Weaver Consultants Group

July 5, 2024
Project No. 0086-364-11-19

Re: Response to Comments
Tier III Permit Modification
Muskogee Community Recycling and Disposal Facility – Permit No. 3551020
Muskogee County, Oklahoma

FIGURE 1

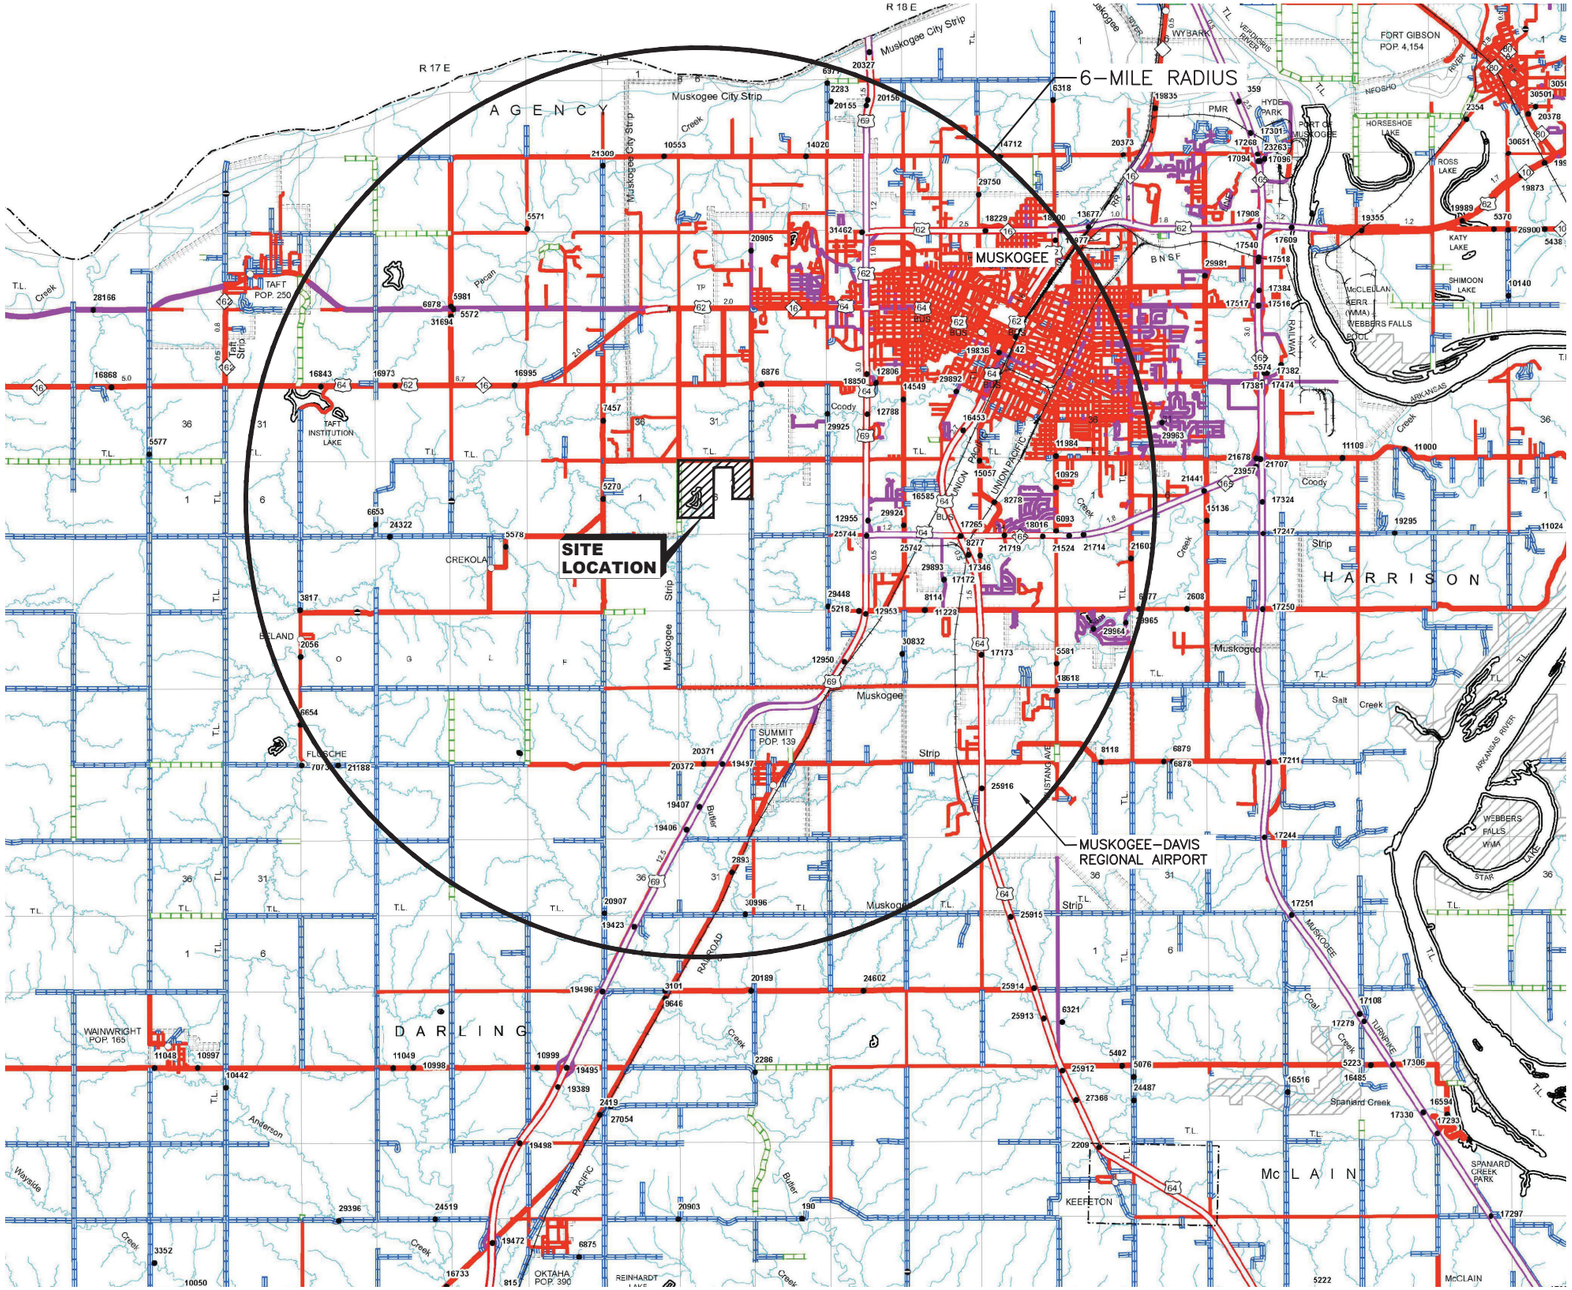
a. General Location Map – Muskogee Airport is shown in the General Site Location Map (Figure 1) in Volume 1 of the Application; however, it is not labeled. In accordance with OAC 252:515-3-52 please revise Figure 1 to identify all airports within six miles of the proposed expansion.

Figure 1 – General Location Map in Volume 1 has been updated to label the Muskogee-Davis Regional Airport

FIGURE 2

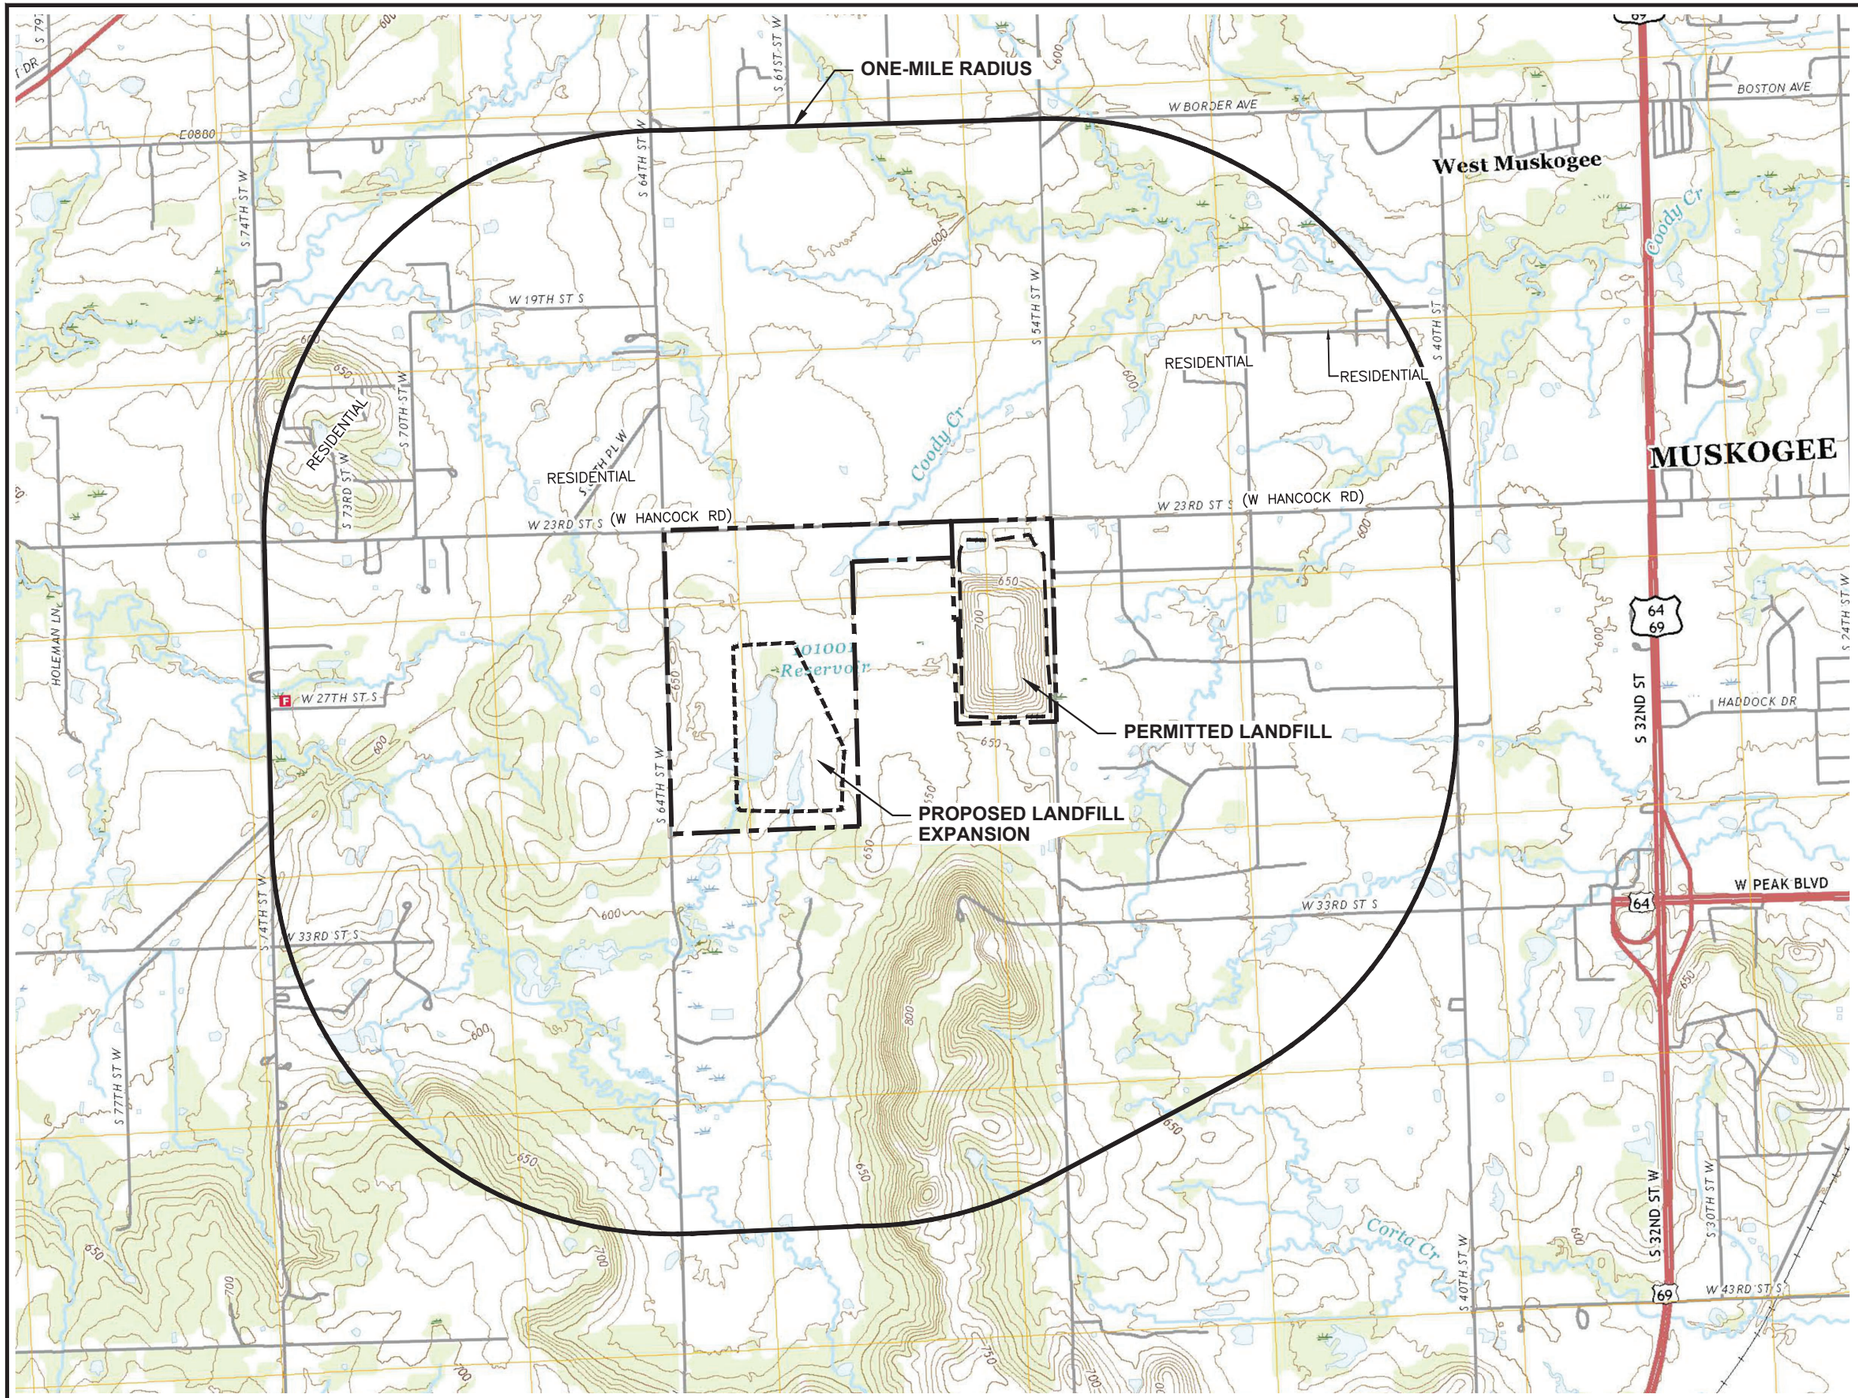
b. Quadrangle Topographic Map – The USGS Topographic Quadrangle Map (Figure E-1-1) in Appendix E, Volume 2A of the Application does not show homes and buildings within one mile of the proposed expansion. In accordance with OAC 252:515-3-54(b)(3), please revise Figure E-1-1 to clearly depict homes and buildings within one mile of the proposed expansion.

Figure 2 – Topographic Site Location Map in Volume 1 has been updated to depict residential areas within one mile of the expansion area. Homes and buildings within one mile of the proposed expansion are more clearly depicted on Figure 3- Land Use Map.

FIGURE 11

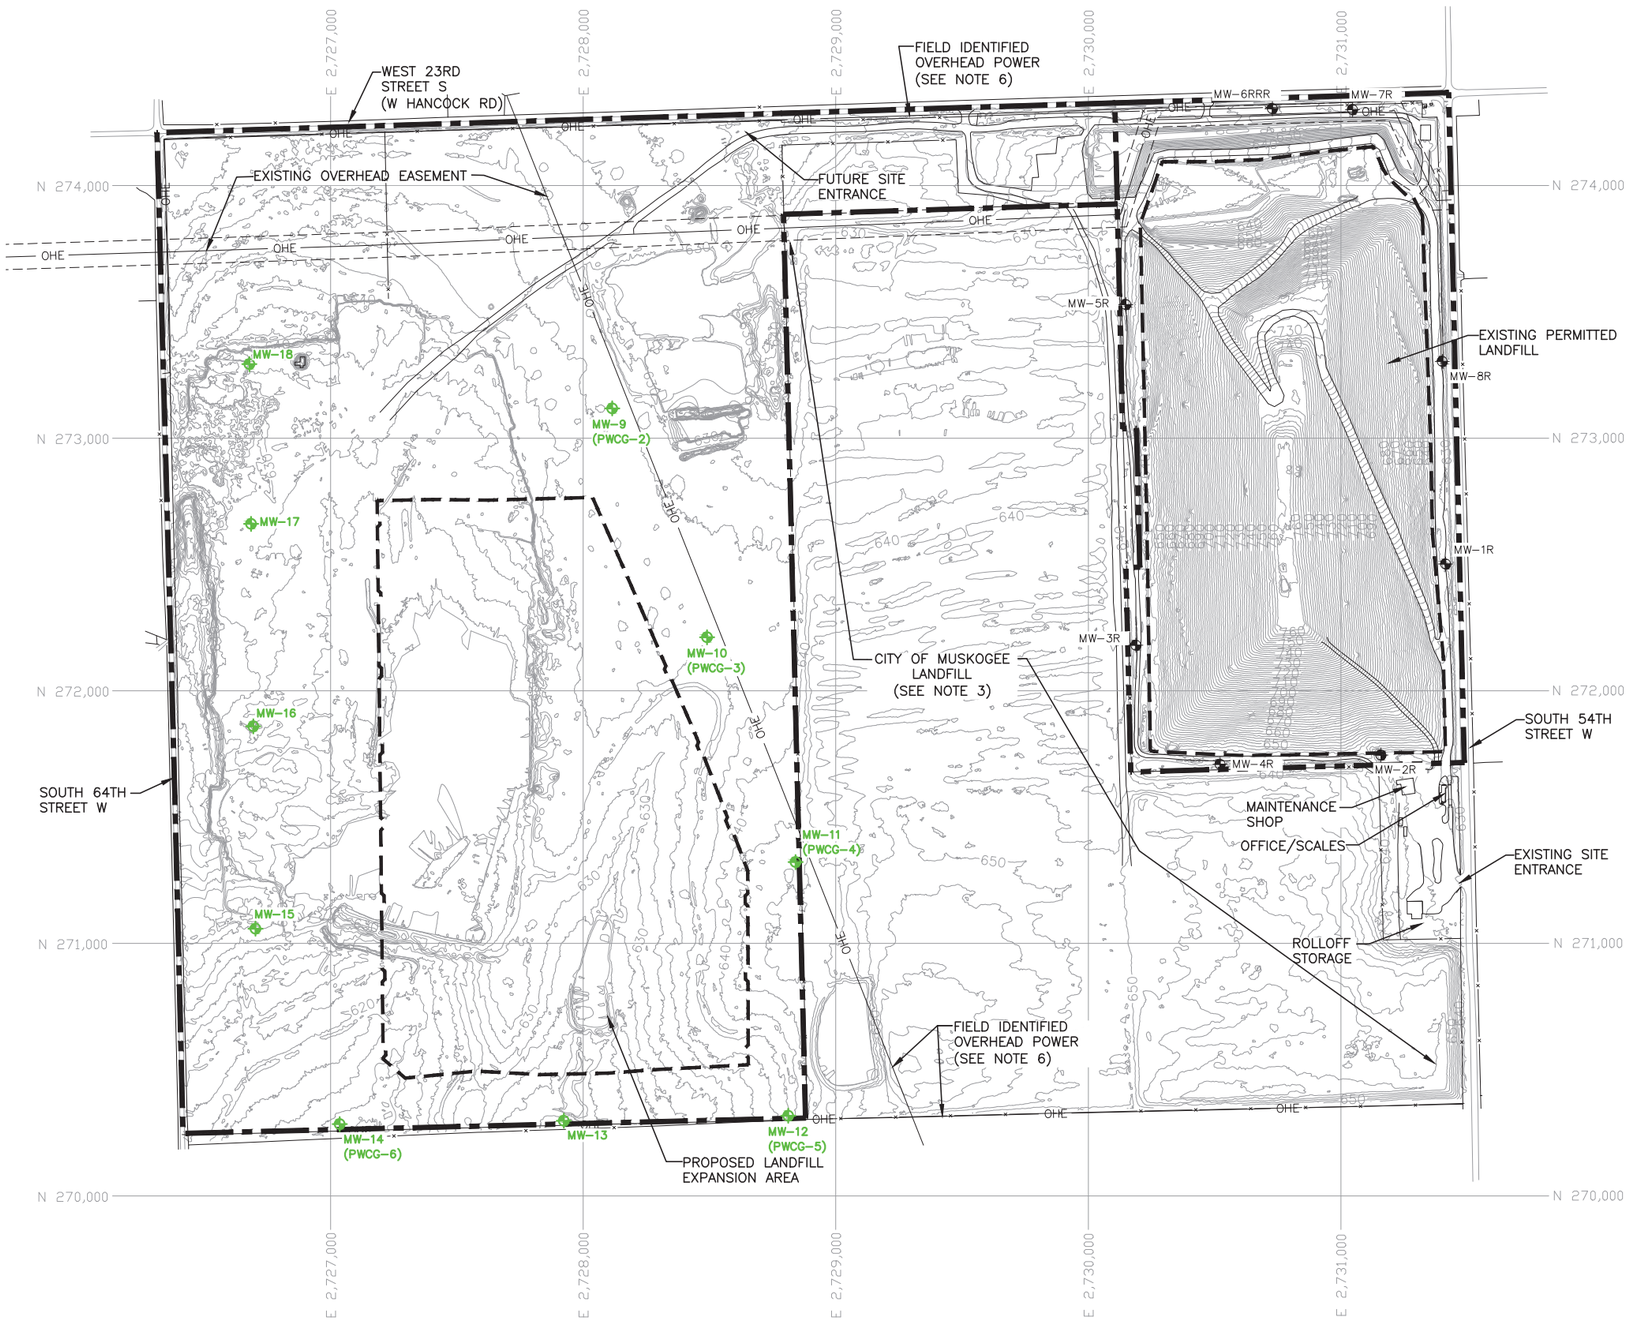
6. Groundwater Monitoring – The Proposed Groundwater Monitoring System (Figure E-1-15) in Appendix E, Volume 2A of the Application depicts the proposed groundwater monitoring wells with respect to the proposed expansion area. According to the scale provided in the figure, the wells on the western side of the proposed permit boundary are over six hundred (600) feet from the proposed limits of waste. In accordance with OAC 252:515-9-4(a) please relocate the proposed groundwater monitoring wells to be no more than 150 yards (-500 feet) from the boundaries of waste disposal.

Figure E-1-15 – Proposed Groundwater Monitoring System has been revised to move the western wells 500 feet from the waste disposal boundary. All drawings depicting monitoring well locations have been revised and included as part of this response.

FIGURE 13

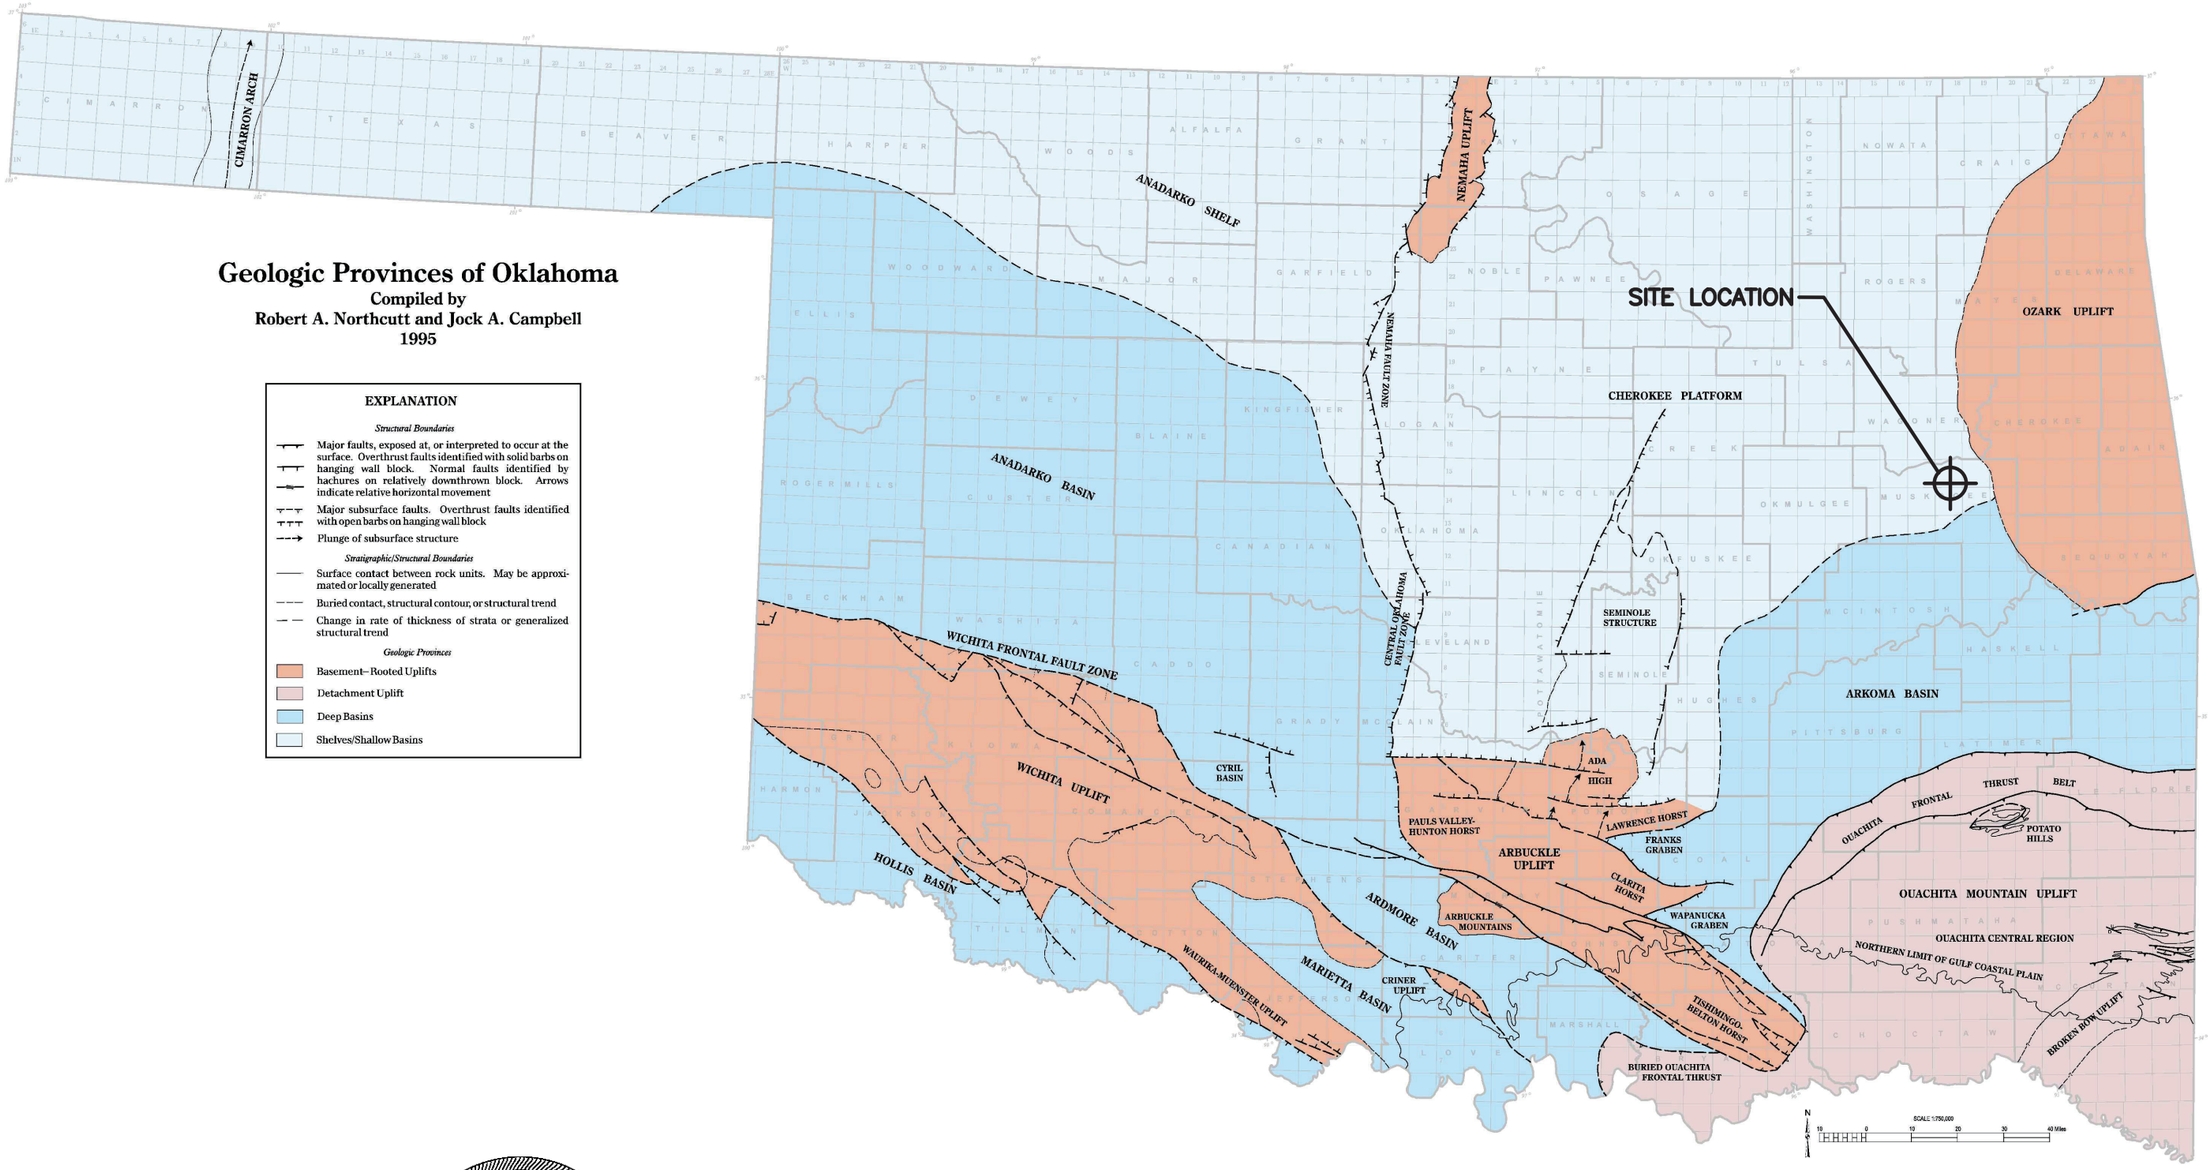
b. Fault Areas – Section 2.13 in Volume 1 of the Application describes the procedure used to determine that the proposed expansion area is not within 200 feet of a fault area as required by OAC 252:515-5-52(b)(1). While an evaluation was completed, the referenced maps were not provided. Please provide excerpts of the maps utilized to make the determination (i.e., the OWRB Interactive Database Map and the Tectonic Map of Oklahoma).

Figure 13 – Fault Areas Map has been added to Volume 1.
